Service Bulletin

XL750R #1

PRODUCT UPDATE CAMPAIGN

2024 XL750R TRANSALP OWNER'S MANUAL MISSING QUICK SHIFTER INSTRUCTIONS

2024 TRANSALP Owner's Manual Rear Cover

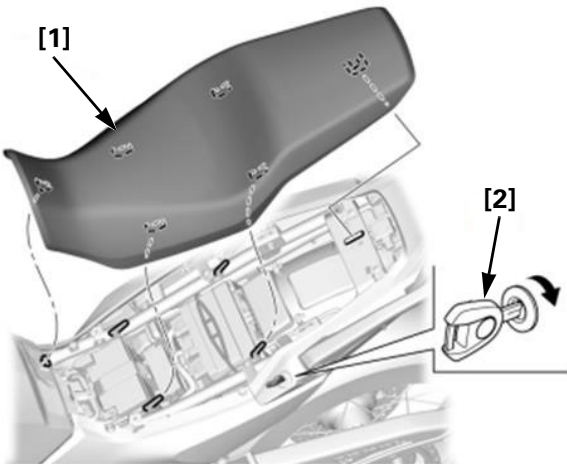
Honda intends to mail customer letters and replacement owner's manuals to all owners of affected 2024 XL750R TRANSALP motorcycles in May, 2024. Customers will be informed that their motorcycle may be affected by a product update campaign and will be advised to discard their original owner's manual with a part number of 00X31-MLC-6000 and begin using the provided replacement owner's manual with part number 00X31-MLC-6010.

2024 TRANSALP Owner's Manual P/N 00X31-MLC-6010
